RETM-230001-REG-APL-0007

**Ridley Island Energy Export Facility -
Application for Amendment #1 to
Environmental Assessment
Certificate #E21-01**

November 17, 2023

Figure 2: Project Layout

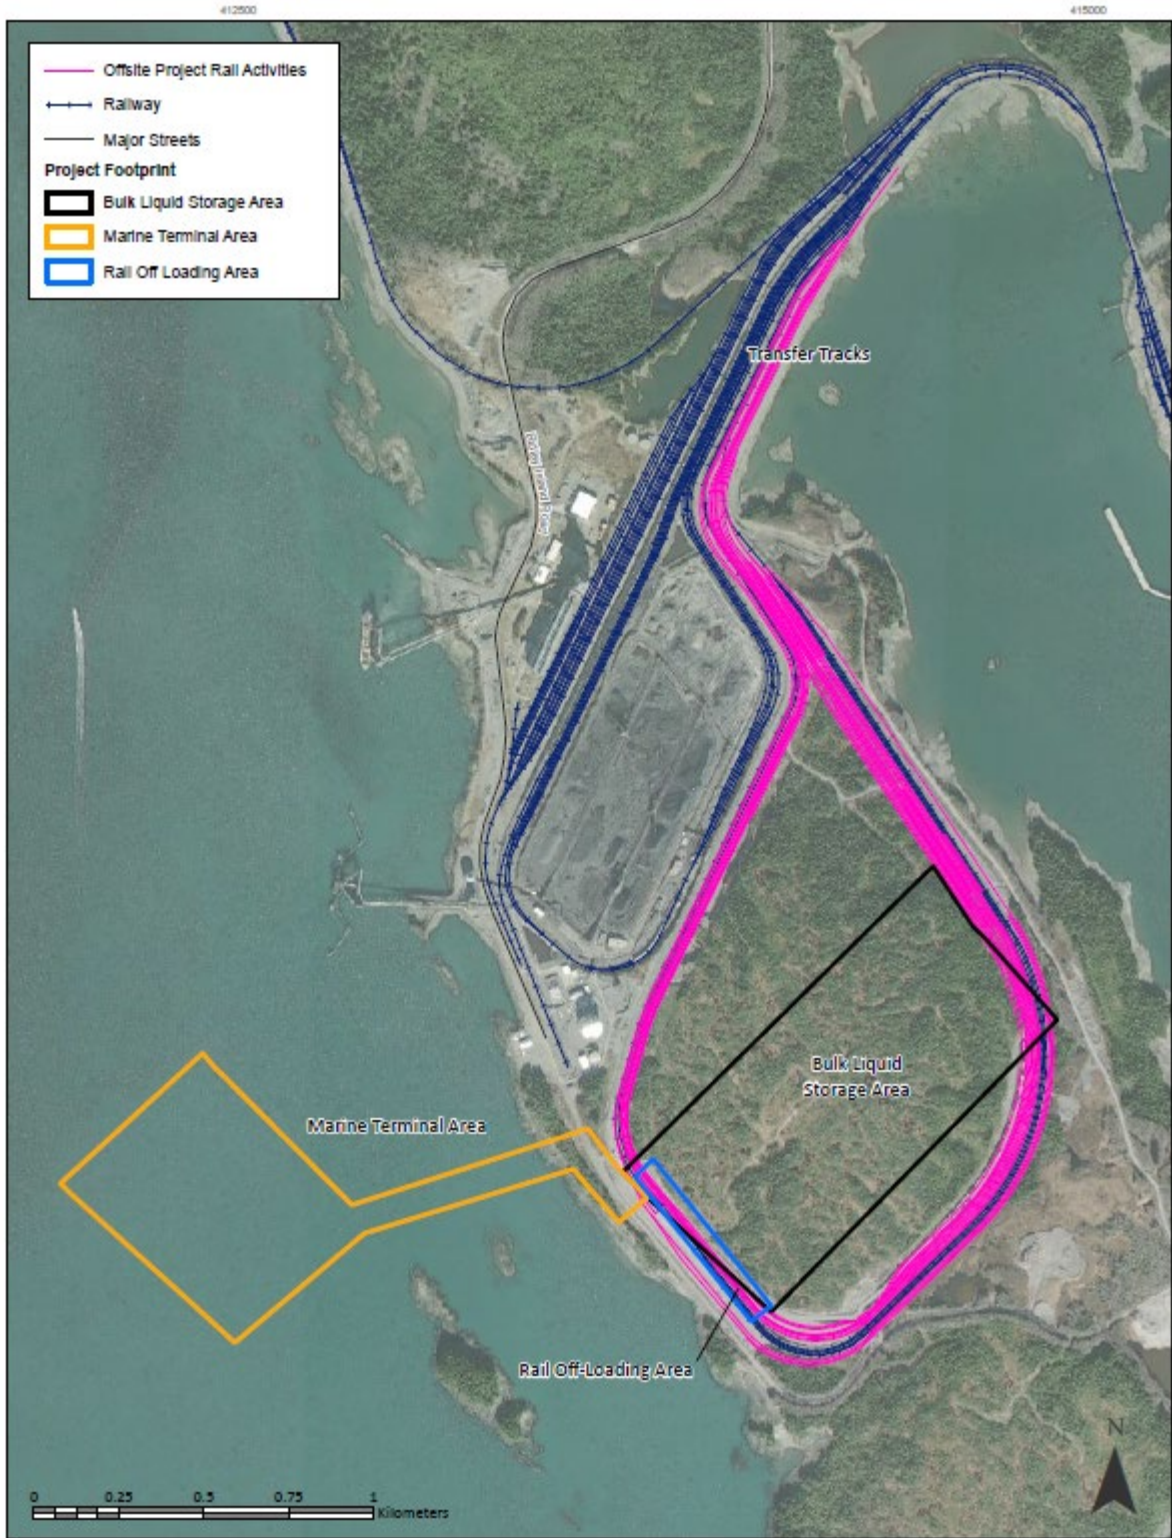
The CPD currently shows the rail unloading rack on the east side of the approved CPD footprint, within the Ridley Island Road, Rail, and Utility Corridor (RRUC) footprint. AltaGas is proposing to move the location of the rail unloading rack to the west side of the Project area. As this is within the planned RRUC footprint, there will be no new biophysical disturbance required for the new rail unloading rack area.

With the change in the CPD described in Section 2.6, the bulk liquid storage area boundary does not line up with the lease boundary. AltaGas is proposing to extend the boundary of the bulk liquid storage area on the northwest side of the area to the lease boundary.

Original and Revised Wording of EAC #21-01	Rationale
Figure 2 (<u>Revised</u> Project Layout) of the Certified Project Description	The Project Layout figure requires updating to show the new location of the rail offloading area and adjustment to the bulk liquid storage facility area.
<p>Note: New text is underlined and text to be removed is shown in strikethrough text.</p>

Figure 2: Revised Project Layout
